**MCPB**  
**3/29/07**  
**Item # 6**

**MEMORANDUM – Local Map Amendment**

**SUBJECT:** **Local Map Amendment No. G-861:** Keating Development Company, Inc., applicant, - reclassification of 2.5 acres of land from the C-4 Zone to the PD-44 Zone for the development of a multi-family dwelling (111 units) with the inclusion of a post office facility on the first floor, located at 7001 Arlington Road, Bethesda MD

ARLINGTON ROAD-ILLUSTRATIVE ELEVATION  
1/32" = 1'-0"

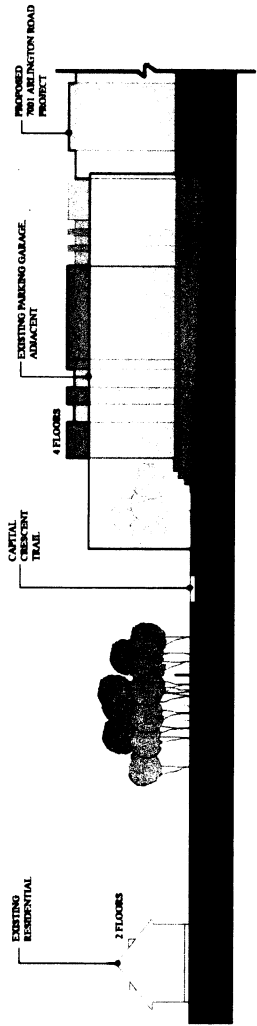
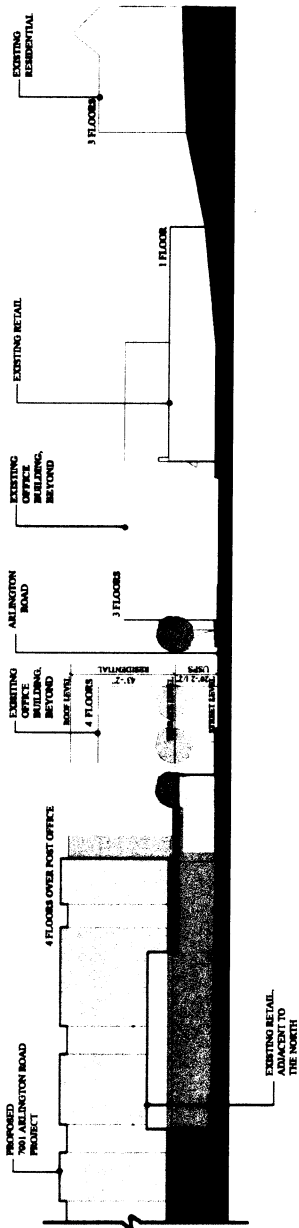
The east end of the proposed development is designed for four floors and does not step down to three stories at the property line with the Capital Crescent Trail as recommended in the 1994 Plan. The proposed housing would be built on a platform on top of the postal facility and associated parking.

Because of the distance from the Sacks community, the intervening 100-foot width of the Trail, and buffer areas, staff does not find four floors incompatible with the neighborhood. The design of the east end of the project, the articulation of the terraces, and the plantings provided at the edge of the property are sufficient to buffer the view of the project from the Trail and the Sacks community. In addition, staff suggested that the below grade garage and the structure be pulled back from the property line, so trees can be planted in the ground and eventually provide a tall backdrop to the project. Working with Parks staff, the applicant may also provide large-scale deciduous trees on the trail side of the property line.

1. The site plan submission should include detailed site and landscape plans which demonstrate that the proposed development has been designed to be compatible with the adjoining Capital Crescent Trail. The Developer shall substantially improve the area between the subject site and the existing paved Capital Crescent Trail so as to create a valuable public amenity. The area should not appear as the back of the 7001 Arlington Road development, but instead be carefully designed by a landscape architect as a public amenity for the thousands of users of the Capital Crescent Trail.
2. At the time of site plan submission, the applicant should be strongly encouraged to contribute towards needed improvements to the recreational facilities in Caroline Freeland Urban Park. If the Applicant seeks off-site credit for the
